1.0 Executive Summary

The purpose of this report is to review and assess the conceptual layout and mode of construction for the on-airport segment of the proposed Automated People Mover (APM) at Fort Lauderdale-Hollywood International Airport. The report focuses on the following four areas of interest:

4.0 Review of Automated People Mover Conceptual Support Structure at Rental Car Facility (RAC)

FIGURE 9
 UTILITY COORDINATION IN RAC AREA
 FOR LAYOUT PROPOSED BY EAC CONSULTANTS
 (BENT 1 THROUGH 9)

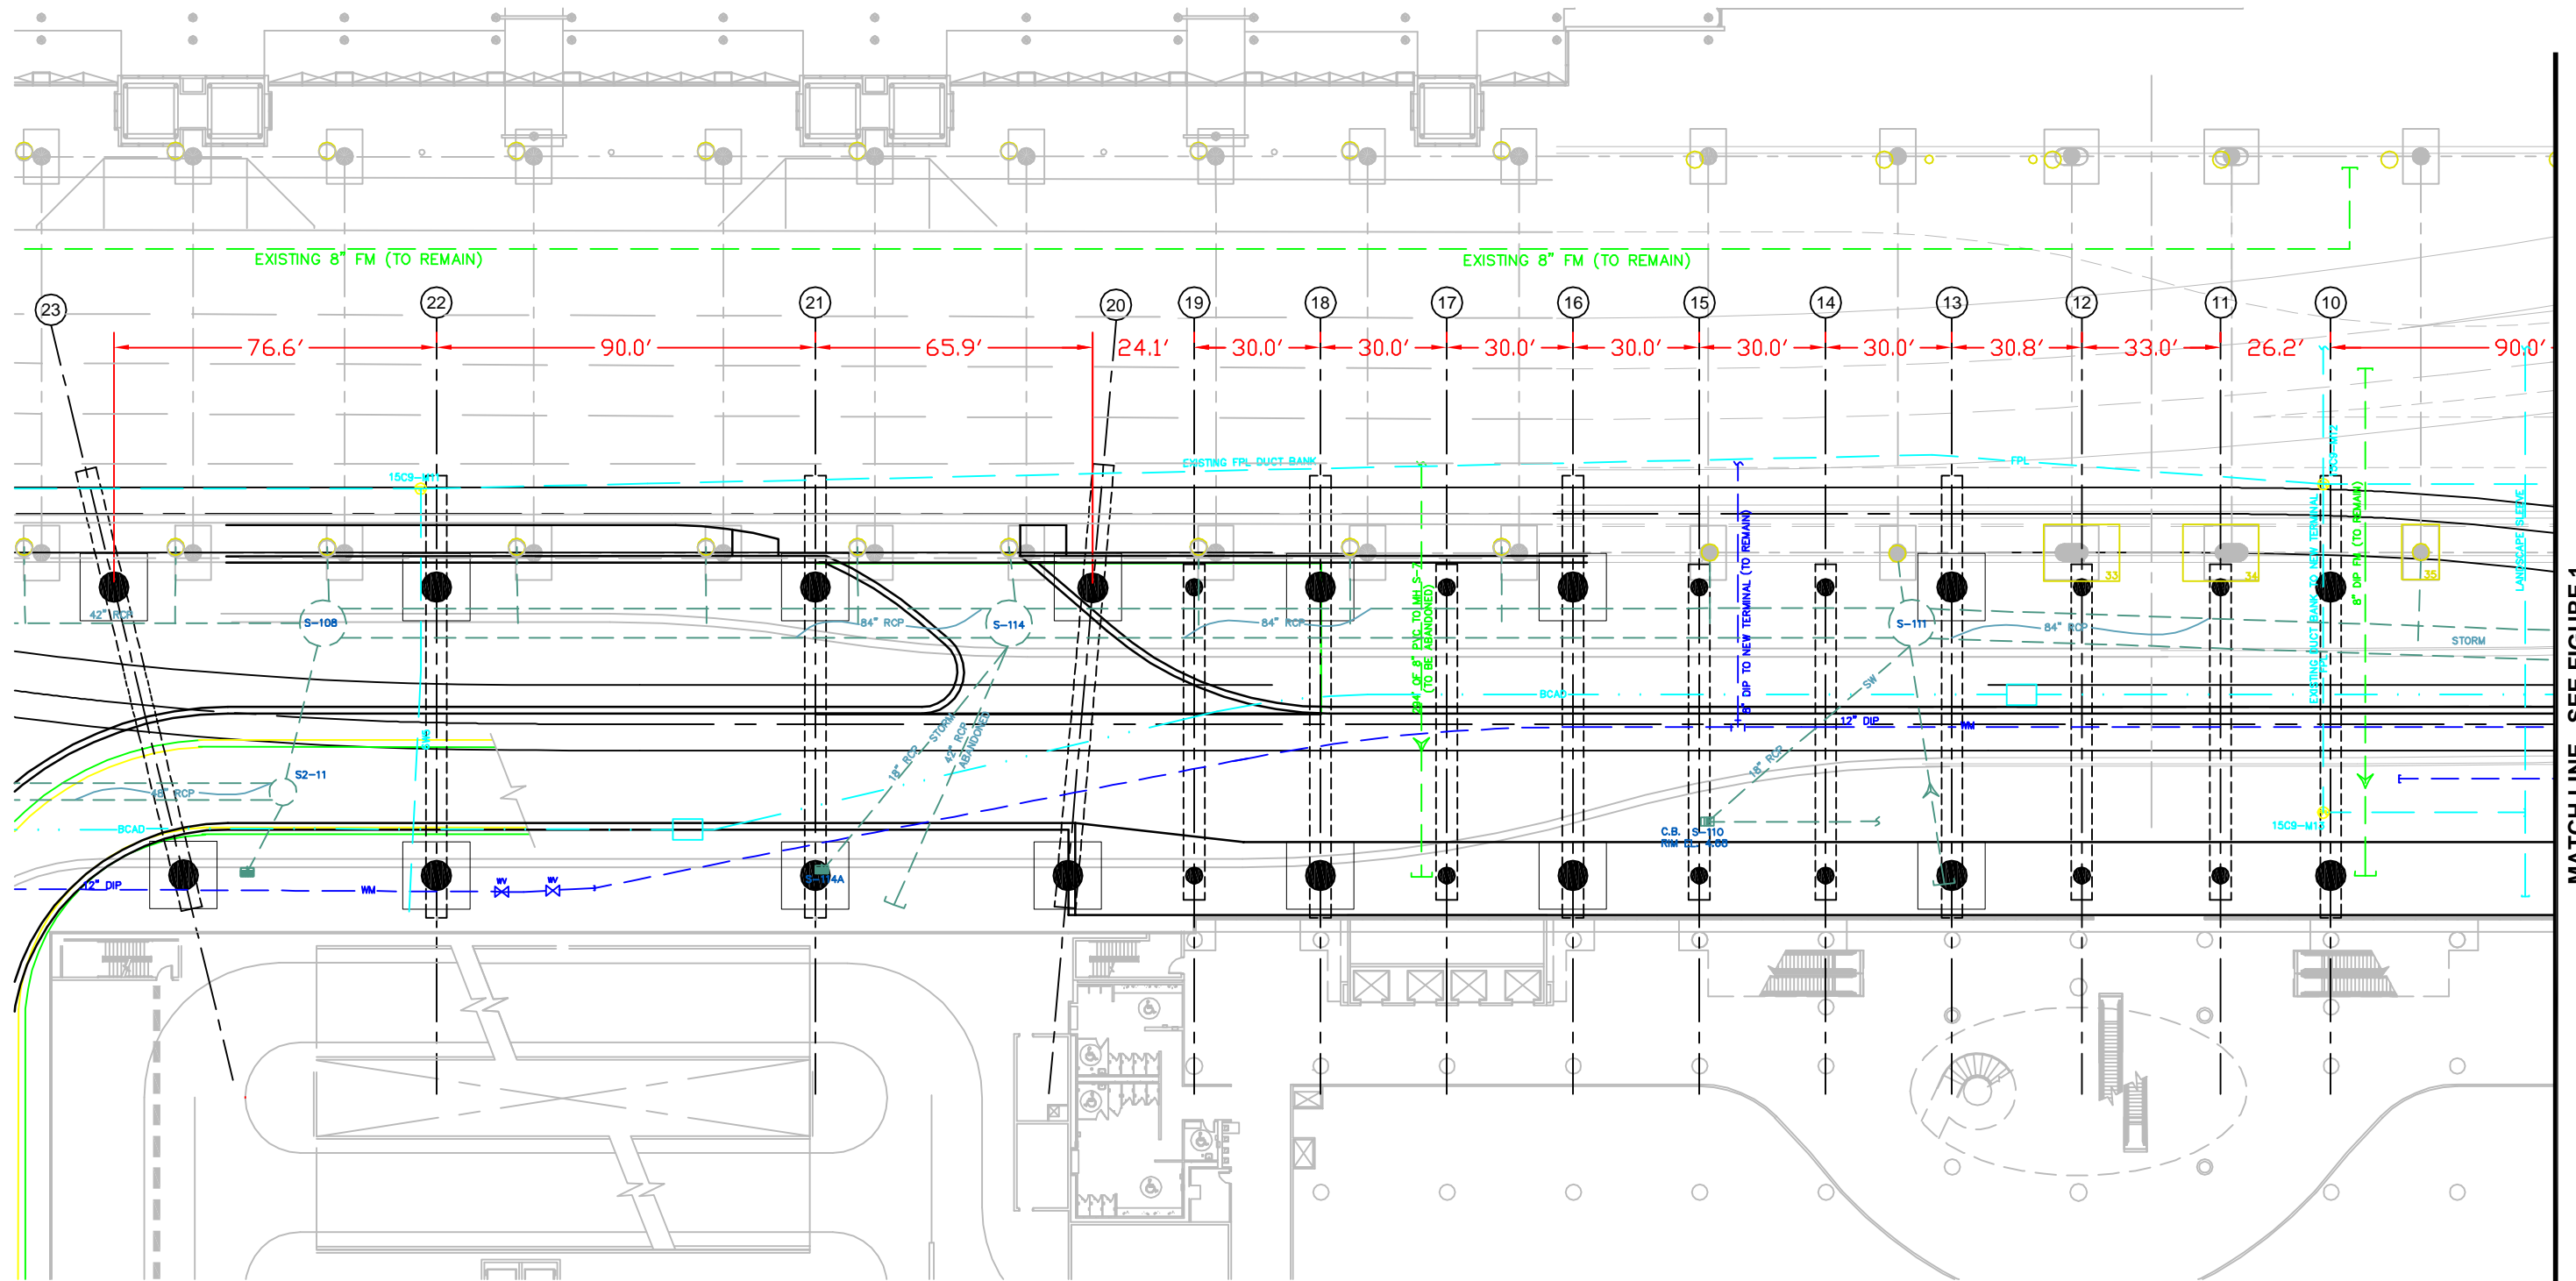
In addition to performing a structural analysis of the support structure for the APM and Busway construction we have also reviewed the layout of the foundation system for the proposed APM support structure with a view of identifying any conflicts with site utilities (See Figures 9 and 10). The following is an outline of possible conflicts

- Bent 1N – conflict with 12” DIP WM.
- Bent 2S – conflict with 8” DIP reclaimed water.
- Bent 2N – conflict with 12” DIP WM and 84” RCP.
- Bent 3N – 84” RCP.

- Bent 3S – conflict with 8” DIP reclaimed water.
- Bent 5S – conflict with 8” DIP reclaimed water.
- Bent 5N – conflict with BCAD and 84” RCP.
- Bent 6aN – conflict with 12” DIP WM and FPL duct bank.

- Bent 7N – conflict with BCAD and 12” DIP WM.
- Bent 10N – conflict with 84” RCP, 8” DIP FM and FPL duct bank.
- Bent 10S – conflict with 8” DIP FM and FPL duct bank.

Upon a review of the existing underground utility locations and the proposed location of the foundation system for the APM we have determined that underground utility relocation is necessary at virtually every proposed column location due to space constraints. The relocation of these utilities is more economical than the alternative which would entail new column locations and thus possibly a larger more expensive and visually unappealing structure. Although it is possible to protect these utilities in place it would not be cost effective to do so for the smaller utility lines, however protection should be considered for the larger utility lines such as the 84” RCP sewer.

FIGURE 11
 PROPOSED BENT LAYOUT FROM WEST OF RAC
 TO JUST SOUTH OF TERMINAL 3
 (BENT 24 THROUGH 50)

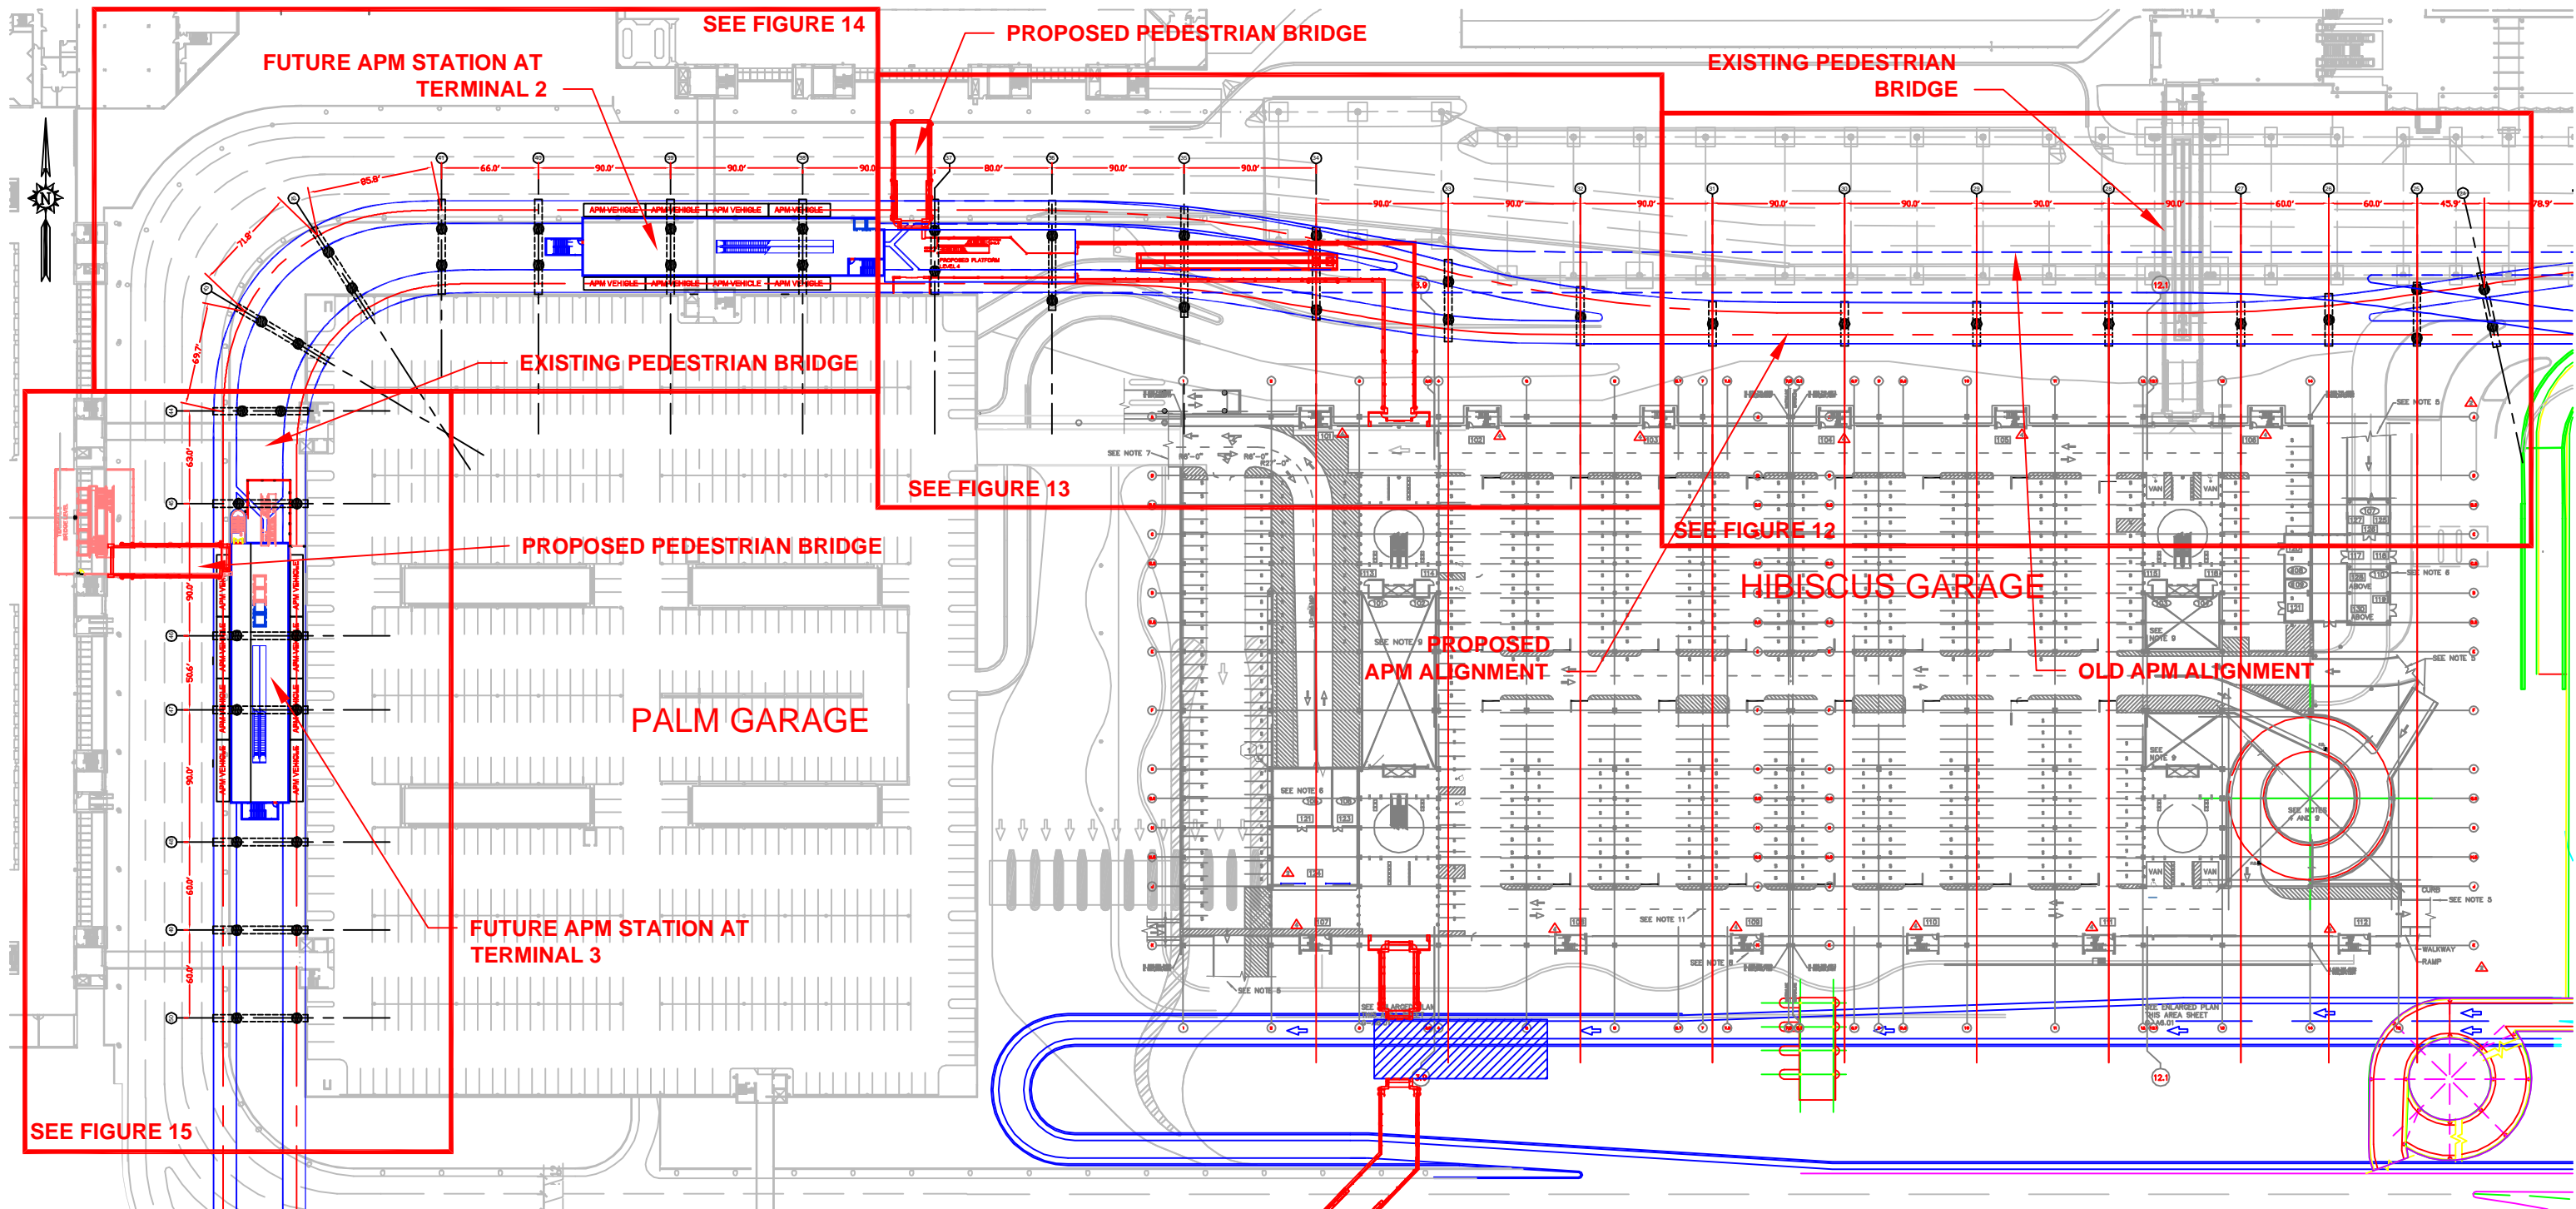
The initial and proposed revised alignment of the guideway for the future construction of the Automated People Mover (APM) in the area West of the Consolidated Rental Car Facility (RAC) to just South of Terminal 3 is shown on Figures 11 through 15. This guideway will necessitate the construction of support piers and bents that need to be incorporated into the existing landscape of the Airport. It is also necessary to take into account current project slated to take place prior to the construction of the APM and to incorporate as much of the future APM support structure into these projects. This will not only reduce the future cost of the APM but it will also minimize the impact that the proposed construction will have on the operations of the Airport.

FIGURE 12

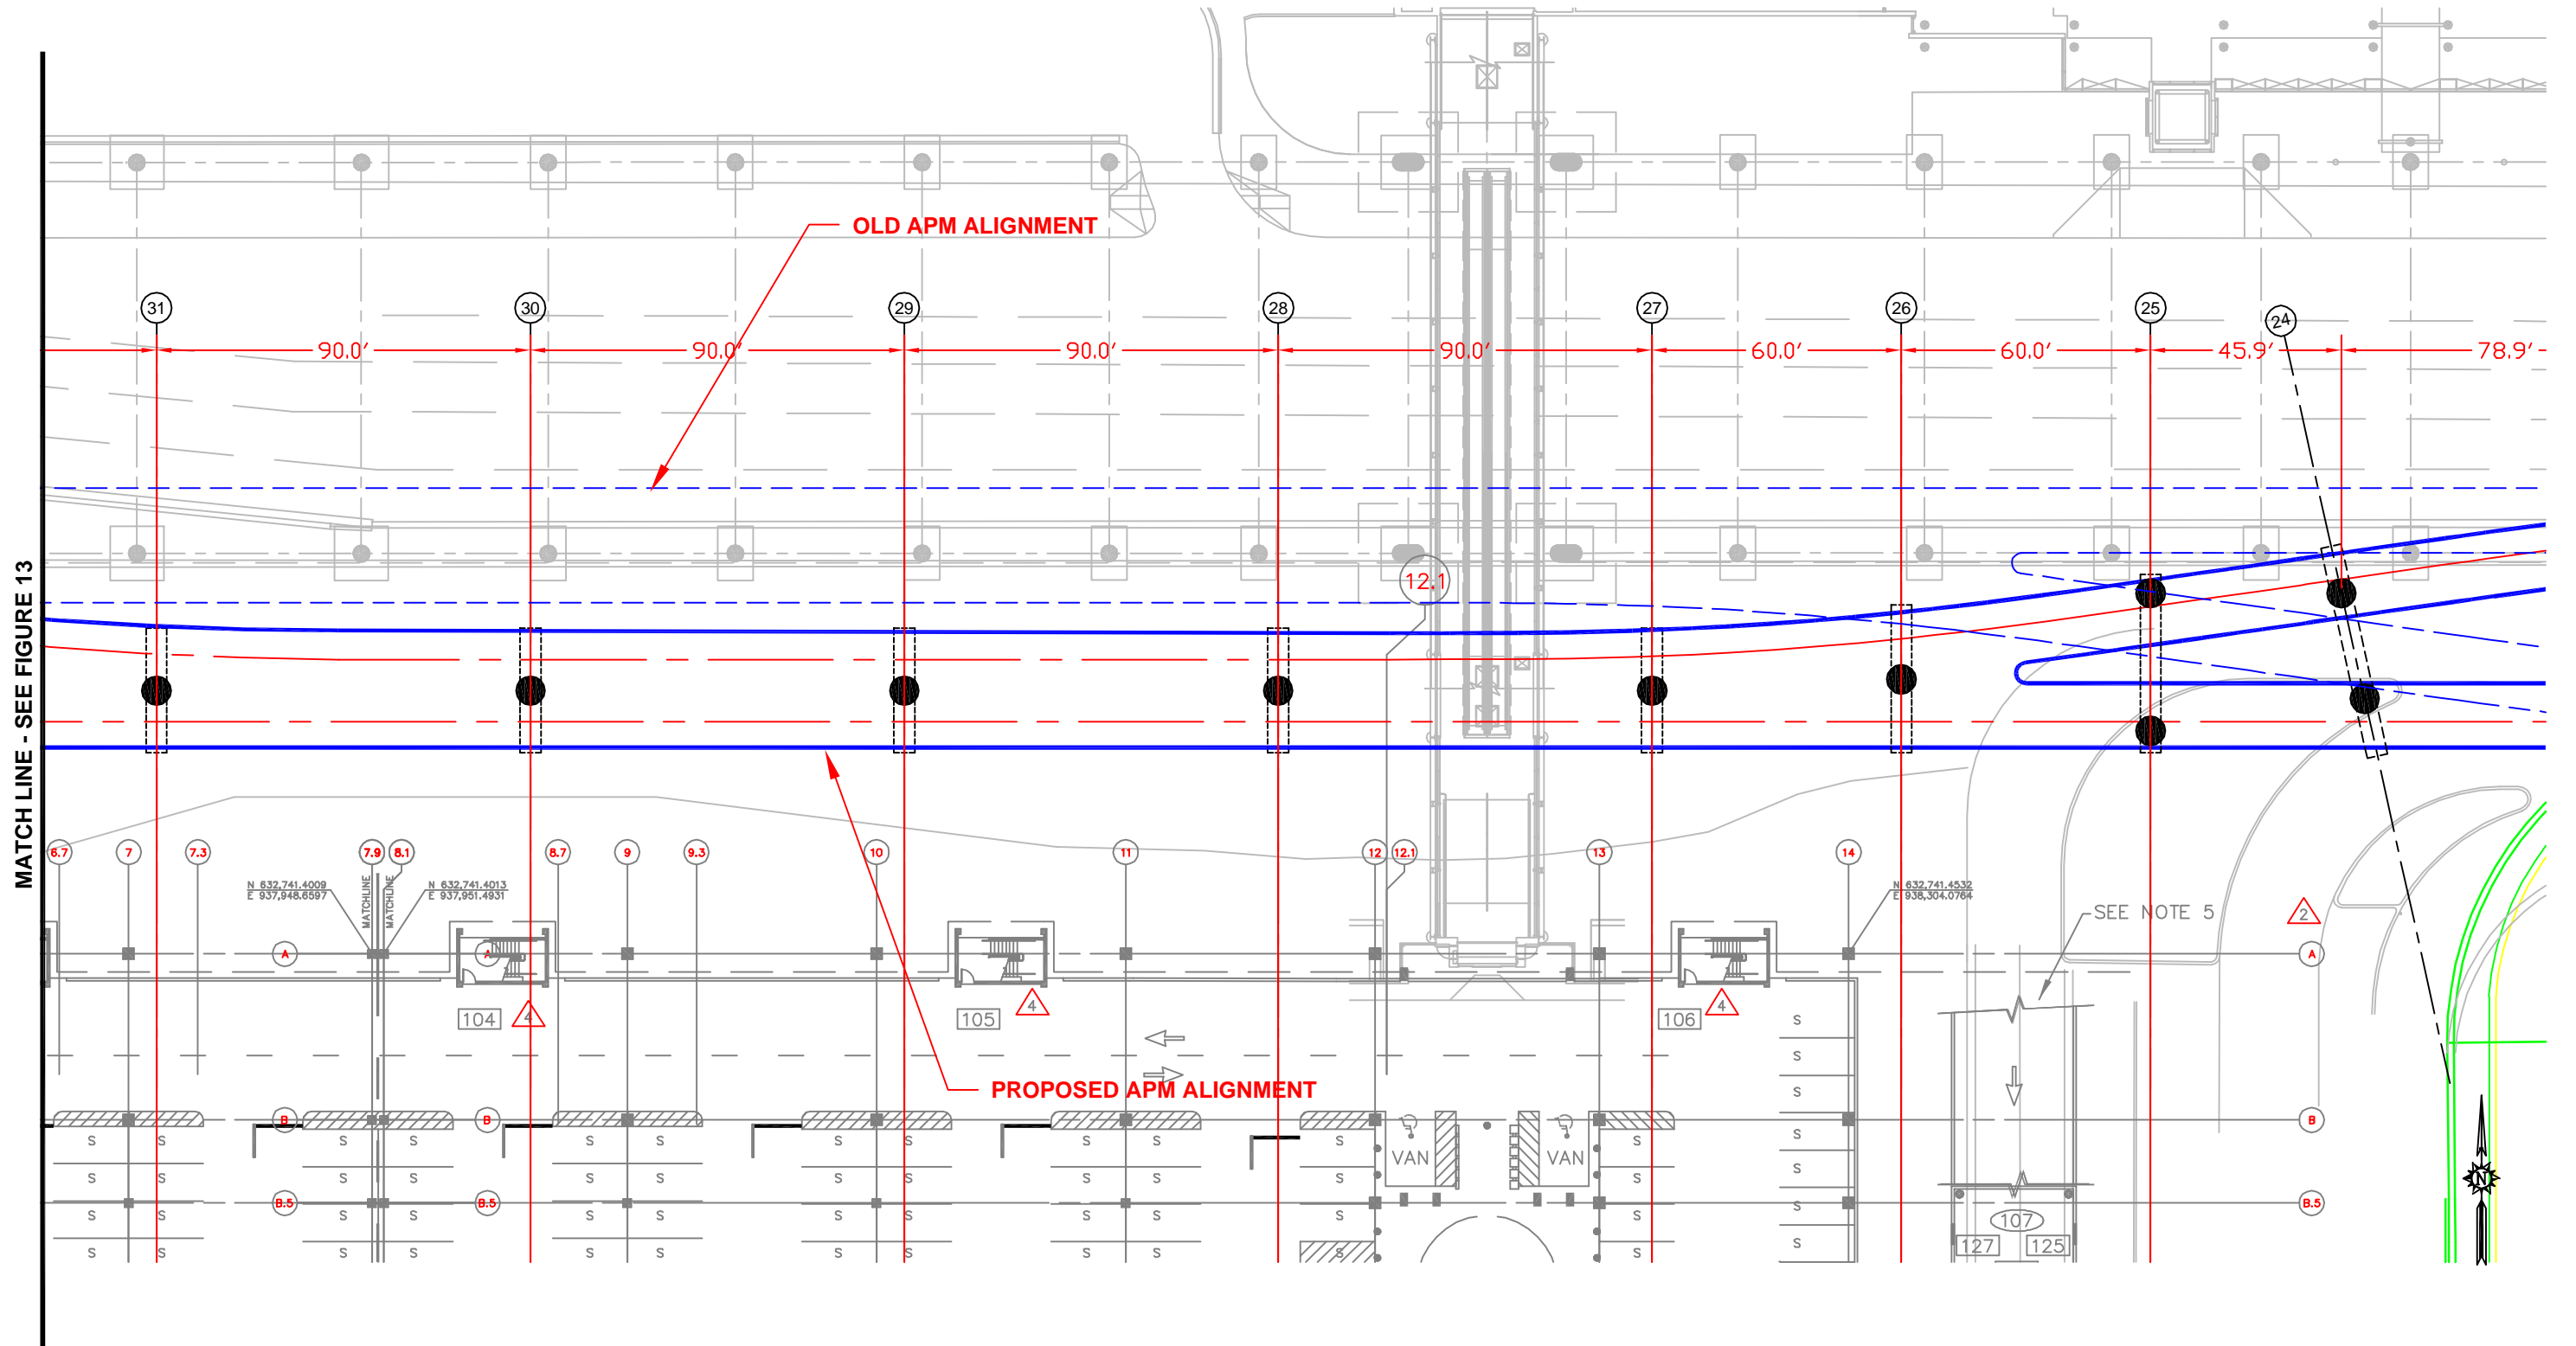
The proposed layout attempts to introduce the structural members required for the support of the APM with minimal interference to the existing structures or operation of the Airport. We have determined that a maximum bent spacing of 90' is the most optimized spacing for the support bents of the APM from a constructability as well as aesthetic point of view. See Figure 12 for Option 2 suggested bent spacing.
